SUBJECT: AMENDMENT NOS.135 AND120 TO FACILITY OPERATING LICENSE NOS. DPR-58
AND DPR-74: (TAC NOS. 73278/73279)

These amendments modify Technical Specification Table 3.3-3 (Engineered Safety
Features Actuation System Instrumentation) so that it more accurately reflects
the actuation signals for the auxiliary feedwater (AFW) system.

SAFETY EVALUATION BY THE OFFICE OF NUCLEAR REACTOR REGULATION
RELATED TO AMENDMENT NO. 135 TO FACILITY OPERATING LICENSE NO. DPR-58
AND AMENDMENT NO. 120 TO FACILITY OPERATING LICENSE NO. DPR-74
INDIANA MICHIGAN POWER COMPANY
DONALD C. COOK NUCLEAR PLANT, UNIT NOS. 1 AND 2
DOCKET NOS. 50-315 AND 50-316

Figure 1 Donald C. Cook Nuclear Plant auxiliary feedwater system

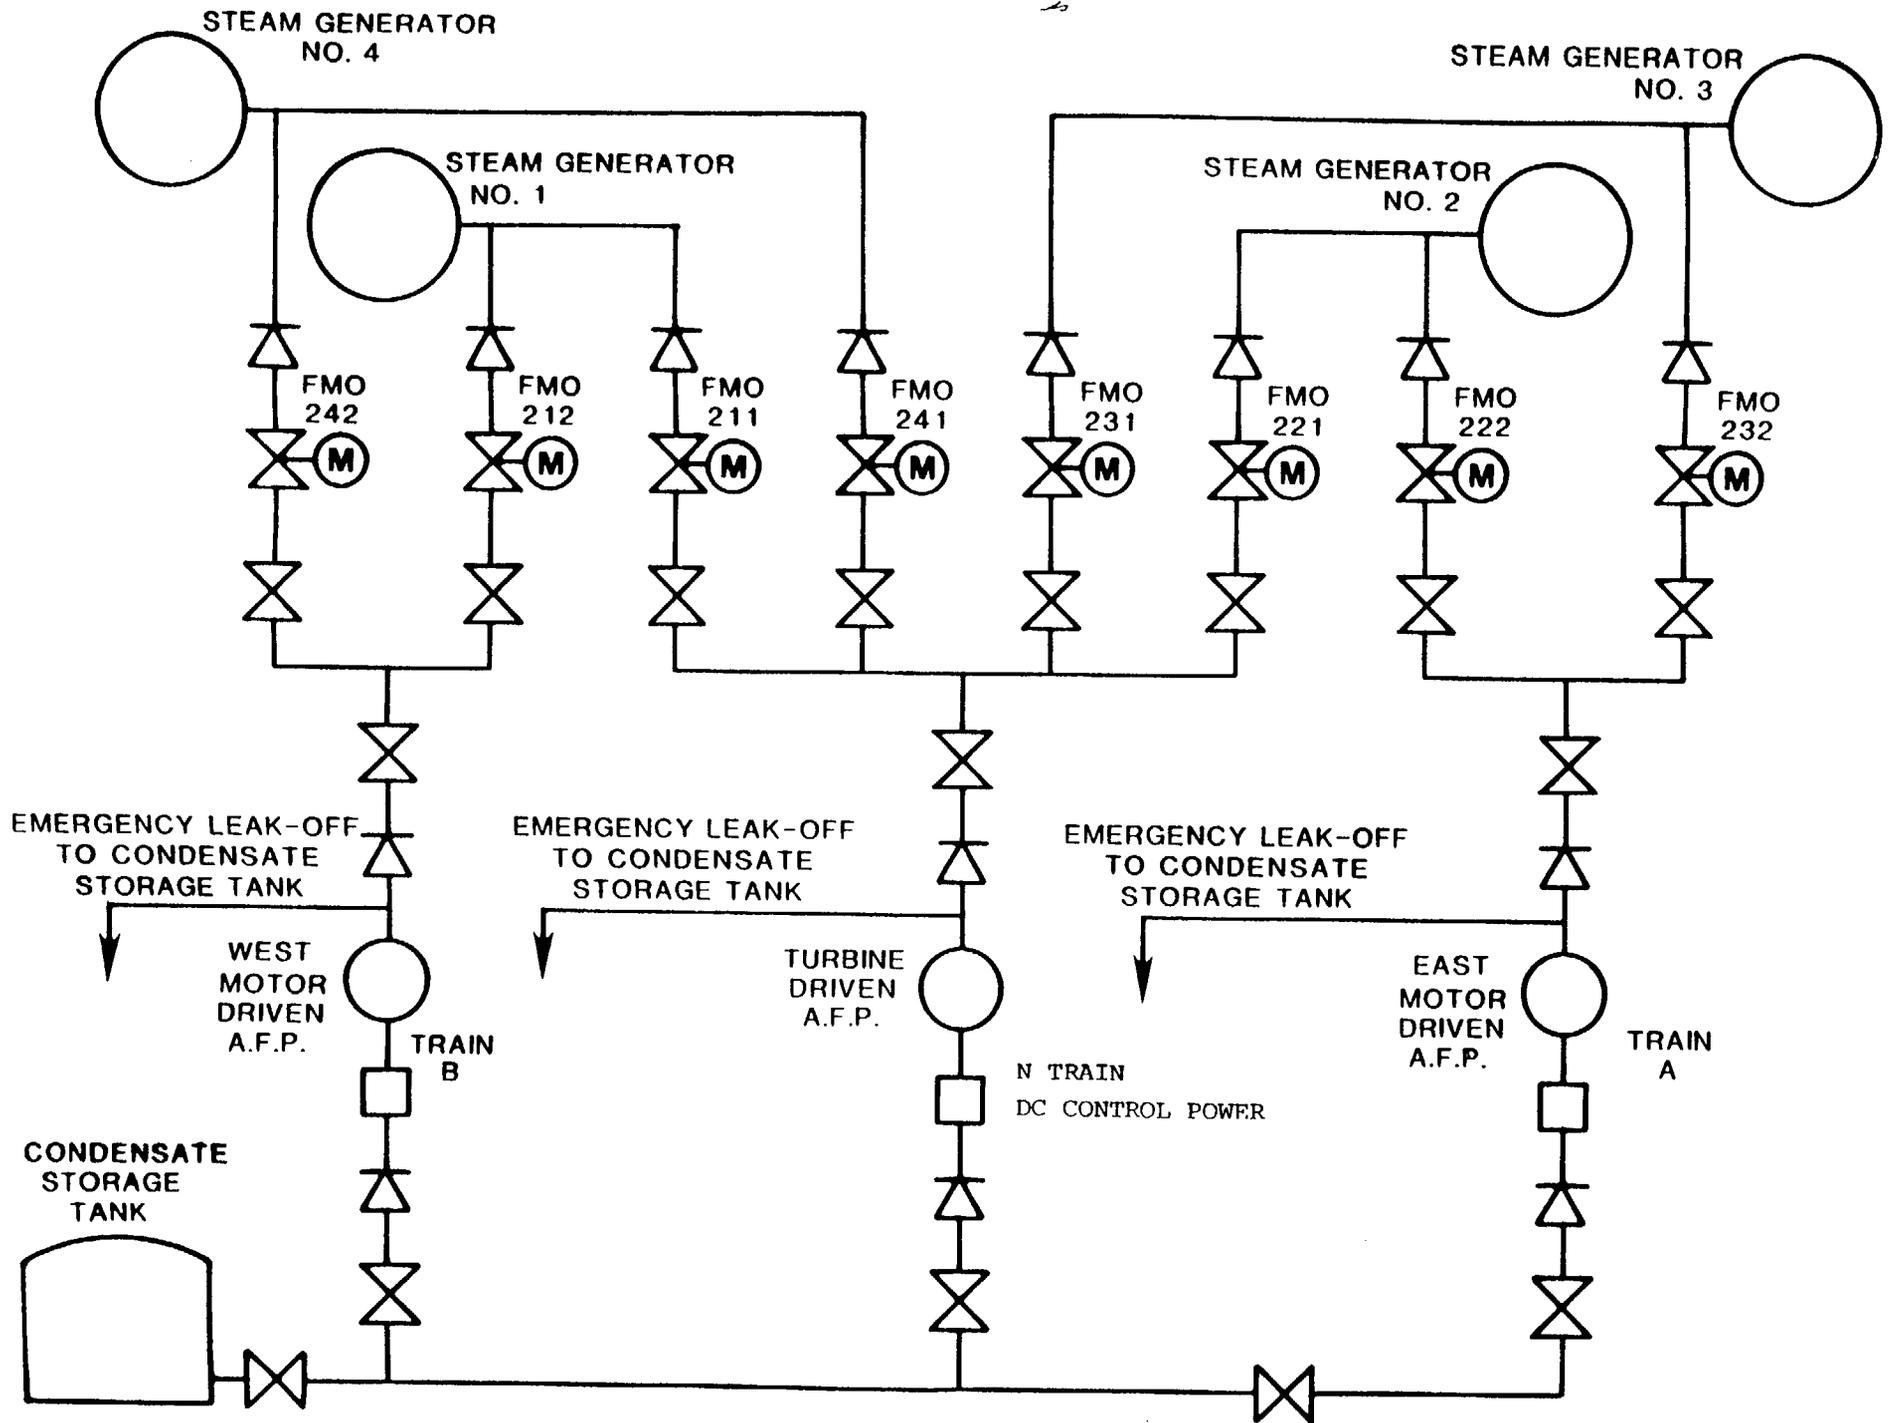
Each D. C. Cook Unit employs two 50% capacity motor-driven auxiliary feedwater (MDAFW) pumps and one 100% capacity turbine-driven auxiliary feedwater (TDAFW) pump. In each unit, the Train A (East) MDAFW pump supplies the No. 2 steam generator (SG) through motor operated valve FMO-222 and the No. 3 SG through FMO-232. The Train B (West) MDAFW pump supplies the No. 1 SG through FMO-212 and the No. 4 SG through FMO-242. This design is illustrated in Figure 1.

Figure 2 Power sources for motor driven auxiliary feedwater pumps and associated valves

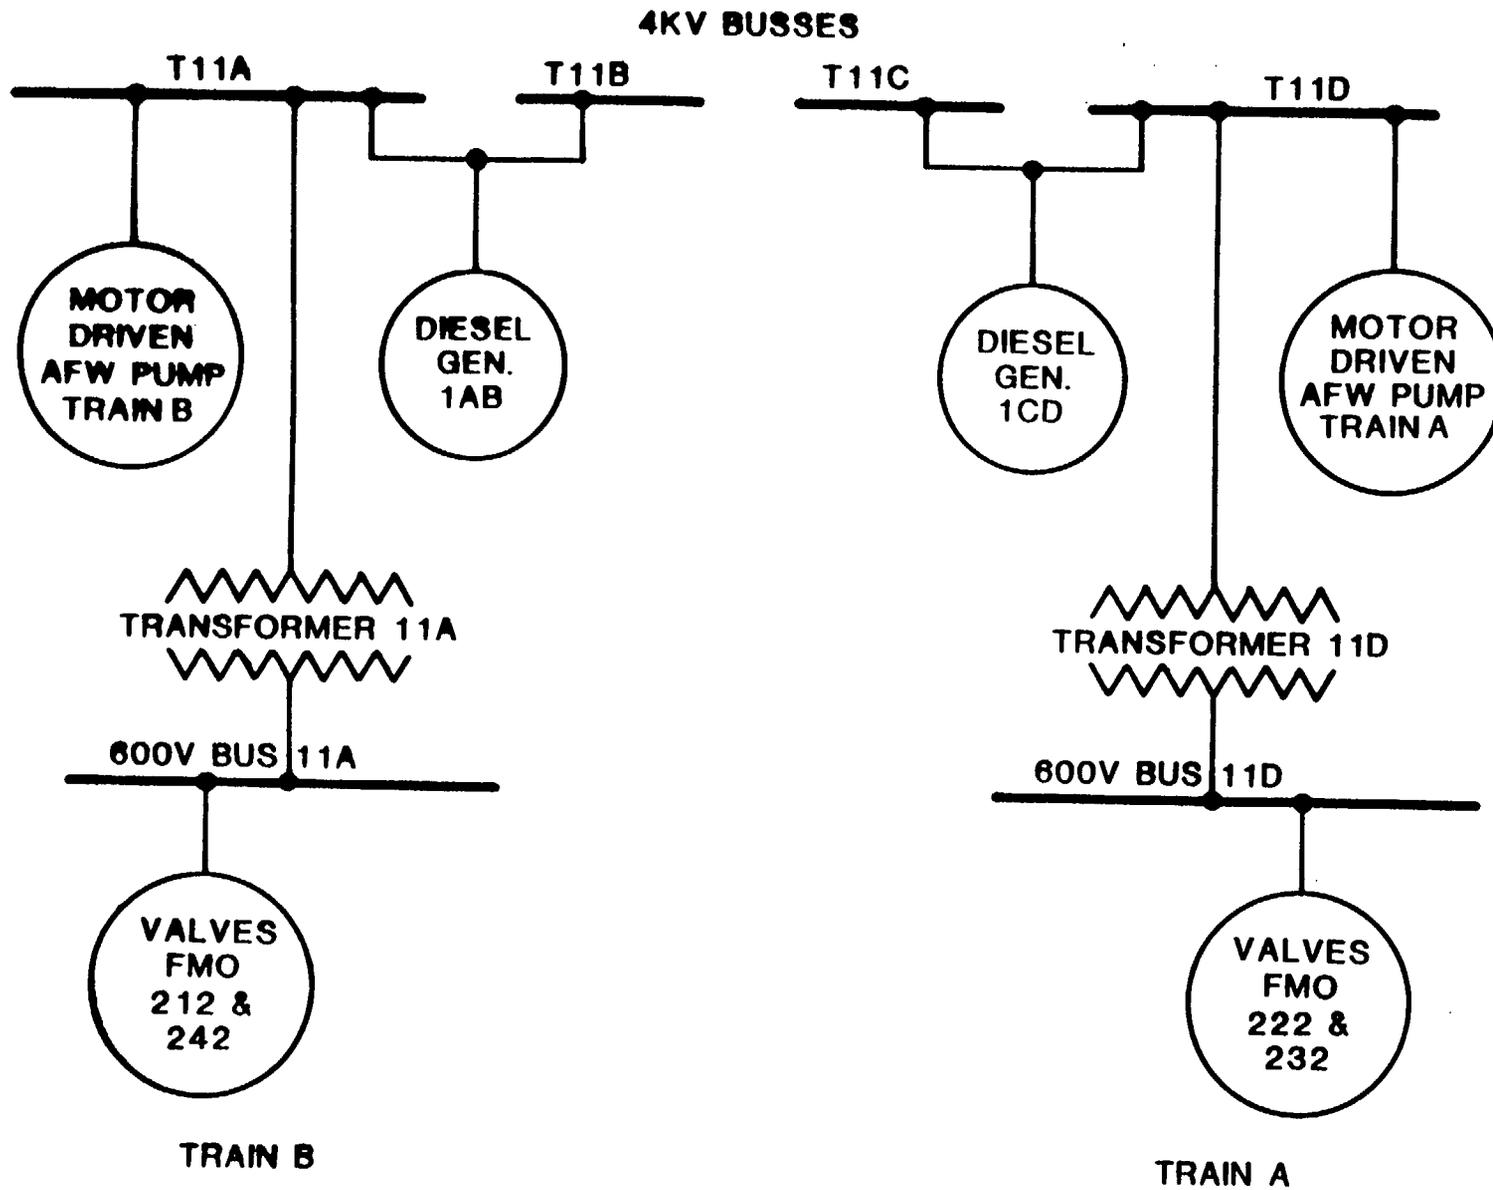
As shown in Figure 2, the emergency power source for the Train A MDAFW pump is 4KV bus T11D. Bus T11D supplies 600V bus 11D (via a 4KV/600V transformer) which provides power to the Train A motor operated valves (FMO 222 and 232). Likewise, bus T11A, the emergency power source for the Train B MDAFW pump, supplies 600V bus 11A which provides power to the Train B motor operated valves (FMO 212 and 242).

Each of the 4KV emergency busses have three loss of voltage relays. Actuation of two out of the three relays on bus T11A will result in auto-start of the Train B EDG and MDAFW pump. Similarly, actuation of any two relays on Bus T11D will start the Train A EDG and MDAFW pump. A loss of voltage condition (2 out of 3) on both safety busses associated with a given train (e.g., T11C and T11D for Train A) will cause motor operated valves in both trains to open, if they are closed.

- * TS Table 3.3-3, Item 6.b (4KV Bus loss of voltage for the MDAFW Pumps) currently lists the total no. of channels as "2/Bus." As discussed earlier this should read "3/Bus."
- * "Valve Actuation" and "Pump start" are added under "4KV loss of voltage." The number of channels to trip for pump start is specified as 2/bus on T11A (Train B) or T11D (Train A). The number of channels to trip for valve actuation is specified as 2/bus on T11A & T11B or T11C & T11D.

The changes described in Section 2 are purely editorial. The changes improve existing TS Table 3.3-3 by correctly specifying the number of loss of voltage channels per bus and by clarifying that both busses of a particular train must indicate a loss of voltage to result in the opening of the motor operated valves that supply flow from the MDAFW pumps. The staff has determined that the changes proposed by the licensee are acceptable.
